**U.S. ENVIRONMENTAL PROTECTION AGENCY
OFFICE OF AIR AND RADIATION
OFFICE OF MOBILE SOURCES**

**ON-BOARD REFUELING VAPOR RECOVERY
POSSIBLE STAGE II REFUELING INCOMPATIBILITIES**

FACT SHEET

FIELD MODIFICATIONS FOR V-34 & V-1 VACUUM ASSIST VAPOR RECOVERY NOZZLES

VAPOR SPLASH GUARD (VSG) REPLACEMENT

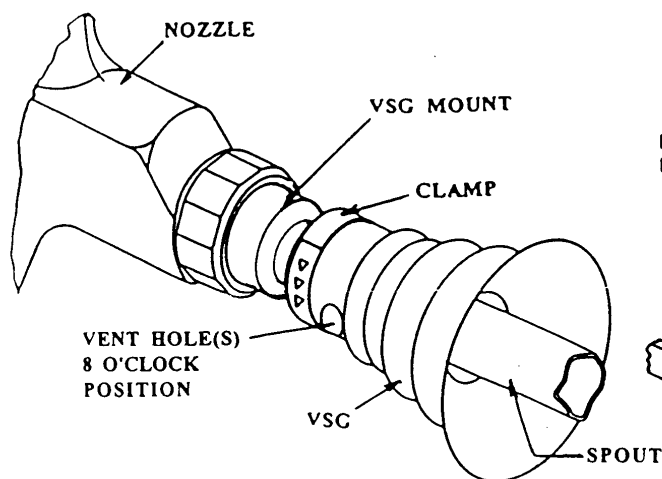
1. Remove the *low profile ear clamp* securing the old *VSG* to the nozzle body using a pair of side cutters or low profile pincers. Squeeze together the two *ears*. This will release the *rectangular tab hole* from the *fourth tooth*.

2. Slide the *VSG* off the *spout*.

3. Replace old clamp or put a new *clamp* on the new *VSG*. Then slide the *VSG* over the *spout* onto the *VSG mount* with the *hole* in the 8 o'clock position.

4. Rotate the *clamp* until the *ears* are to the lower side of the nozzle. With a *low profile pincers* or a *side cutters*, grasp the two *ears* and squeeze them together until the *rectangular tooth hole* latches over the *fourth tooth*. The *clamp* must be tightened firmly to prevent the *VSG* from rotating.

VAPOR SPLASH GUARD (VSG) IN FIELD MODIFICATION

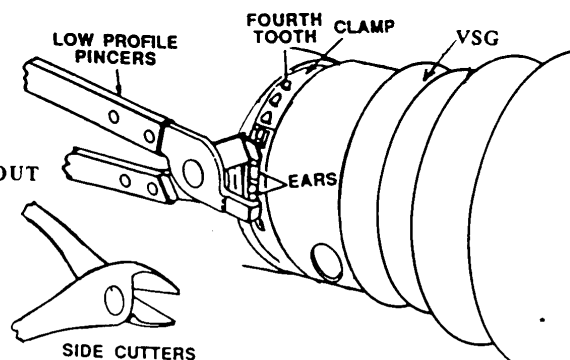
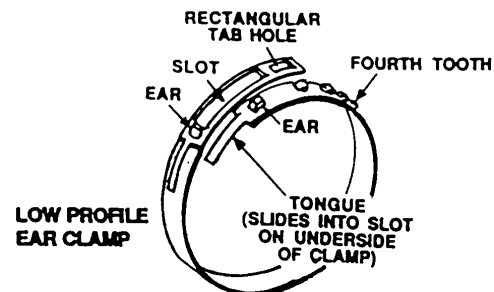
1. The existing *VSG* can be converted to the new ORVR design by using a suitable hole punch (leather punch) to replace the existing 1/8" hole with *four 3/16" holes* or one 3/8" hole.

2. Follow replacement instructions. Placing the holes in the 8 o'clock position.

FOUR 3/16" HOLES

ONE 3/8" HOLE
